SUBDIVISION COMMITTEE
METROPOLITAN AREA PLANNING COMMISSION

STAFF REPORT
(Preliminary Plat)

CASE NUMBER: S/D 91-20 - THE ABBY AT FAIRFIELD ADDITION

STAFF REPORT
(Final Plat, Preliminary Plat Approved 4/18/91)

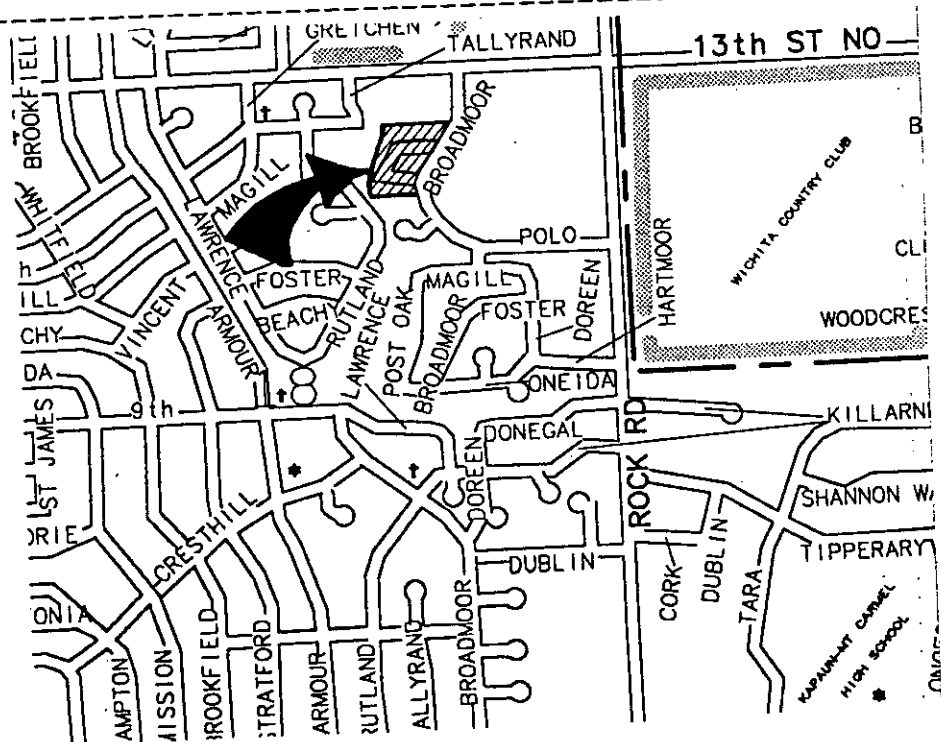
- A. City Engineering needs to indicate if existing petitions should be abandoned for this site and new petitions provided for sanitary sewer, drainage, street paving and water. If projects are to be abandoned as a result of this replat, the applicant shall pay off any charges against any abandoned improvements.

- B. The applicant shall guarantee the paving of the proposed private interior streets to the 29-foot public street standard.
- C. If improvements are guaranteed by petition, a notarized certificate listing the petitions shall be submitted to the Planning Department for recording.

- D. The Community Unit Plan (DP-146) allowed a church use as part of Parcel 1. This replat proposes a church use on Lot 1, which is associated with Parcel 2 which restricts uses to Zero lot line, patio homes, single family, townhouses and associated community facilities. The applicant must file for an adjustment to the C.U.P. in order to provide for a church use in Lot 1 of Parcel 2. The final plat tracing shall not be submitted until the associated C.U.P. has been adjusted to provide for a church use.

- I. Regarding Reserve A, which is being platted for private drive purposes, discussion with the Law Department indicates a need for language in the covenant which sets forth ownership and maintenance responsibilities of the reserve, to establish future reversionary rights of the reserve to the lots benefiting from the reserve.

- J. As indicated by this plat, a standard cul-de-sac or turnaround is being proposed by this plat. Such a standard turnaround must be approved by City Engineering. Engineering needs, therefore, to indicate the acceptability of this design. Further, Engineering should indicate if the configuration of this street should require a 15-foot street-drainage-utility easement to be platted along all lots adjacent to Broadmoor Court.

- O. On the final plat, a 20-foot utility easement shall be indicated at the southeast corner of lot 9 in order to adequately cover the existing sanitary sewer line at this location. Further, an additional 5-foot portion of easement should be indicated along Reserve A or in lot 10 to cover the same sanitary sewer line. A 20-foot easement should also be provided across Reserve B for

this sewer line. If the applicant choose, Reserves A and B could simply be indicated as allowing utilities but dropping reference to the utilities being confined to easements.

- P. If easements are not being platted within the Reserves, particularly Reserves A & C, reference to utilities being confined to such easements should be dropped from the descriptions on Reserve uses.

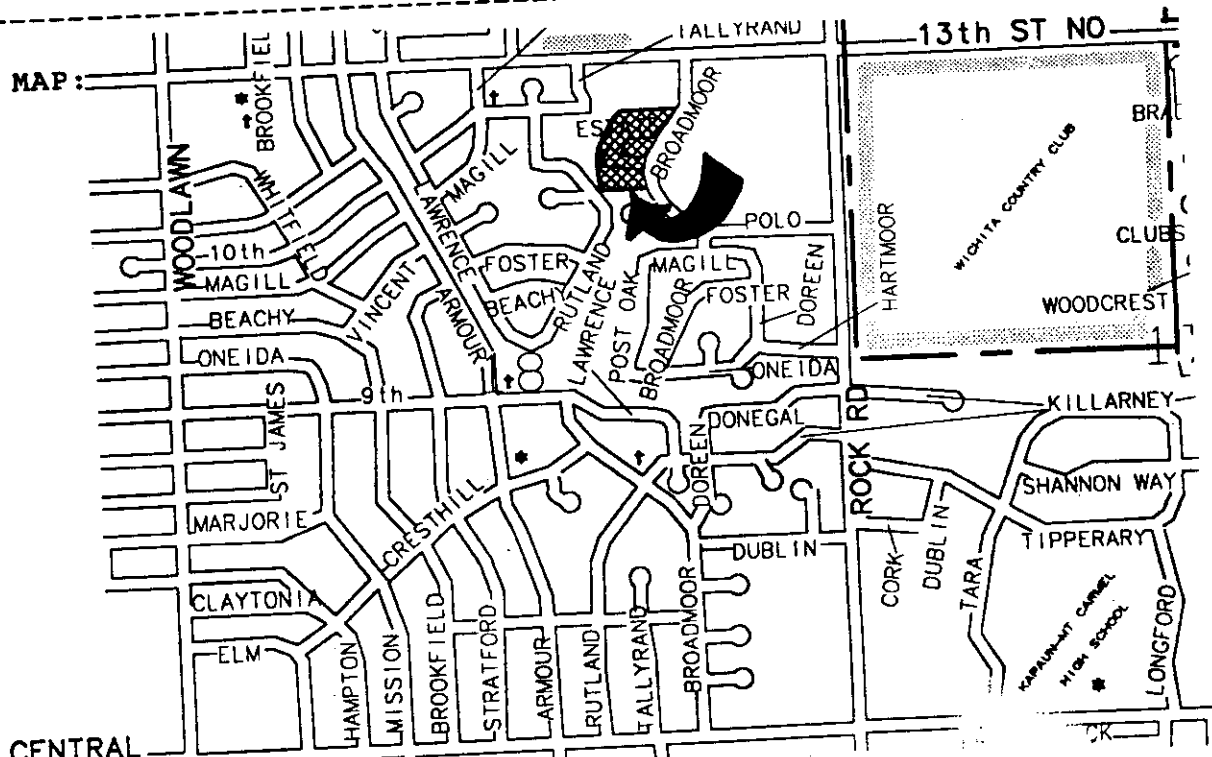
- A. The applicant shall submit square footage figures to Engineering or an agreement to provide for the redistribution of specials for sanitary sewer. New petitions shall be submitted for water and paving. If projects are to be abandoned as a result of this replat, the applicant shall pay off any charges against any abandoned improvements.

- B. The applicant shall guarantee the paving of the proposed private interior street, shown as Reserve "A," to the 29-foot public street standard.
- C. If improvements are guaranteed by petition, a notarized certificate listing the petitions shall be submitted to the Planning Department for recording.

- D. The Community Unit Plan (DP-146) allowed a church use as part of Parcel 1. This replat proposes a church use on Lot 1, which is associated with Parcel 2 which restricts uses to Zero lot line, patio homes, single family, townhouses and associated community facilities. The applicant must file for an adjustment to the C.U.P. in order to provide for a church use in Lot 1 of Parcel 2. The final plat tracing shall not be scheduled for City Council review until the associated C.U.P. has been adjusted to provide for a church use.

- E. At the time the preliminary plat was approved, the applicant was required to meet with City Engineering to determine if the proposed street design for Broadmoor Ct. was acceptable. Engineering needs to indicate if the design shown on the final plat is acceptable.

- H. Regarding Reserve A, which is being platted for private drive purposes, discussion with the Law Department indicates a need for language in the covenant which sets forth ownership and maintenance responsibilities of the reserve, to establish future reversionary rights of the reserve to the lots benefiting from the reserve.

- I. Since this plat proposes the platting of narrow street rights-of-way with adjacent "15-foot public drainage, utility and private street easement," a restrictive covenant shall be submitted which calls out restrictions for lot-owner use of these easements. Retaining walls and change of grade shall be prohibited within these easements as well as fences, earth berms and mass plantings. Any planting within this easement shall be reviewed by the City Forestry Division prior to installation.

- J. The applicant shall submit a covenant which provides for four (4) off-street parking spaces per dwelling unit on each lot which abuts a 32-foot public or private street (drive). The covenant shall inventory the affected lots by lot and block number and shall state that the covenant runs with the land and is binding on future owners and assigns.

- K. On the final plat tracing, the platlor's text shall note that the parking allowed in Reserve B is confined to the indicated parking easements. Further, the applicant needs to provide for the maintenance and ownership of these parking areas. Also, these areas are intended for guest type parking and not for the storage of boats, campers, and other such vehicles. The covenant concerning the ownership and maintenance of Reserve B should clearly address these requirements for the indicated parking easements. Traffic Engineering needs to also indicate if the location of these easements pose any safety problems.
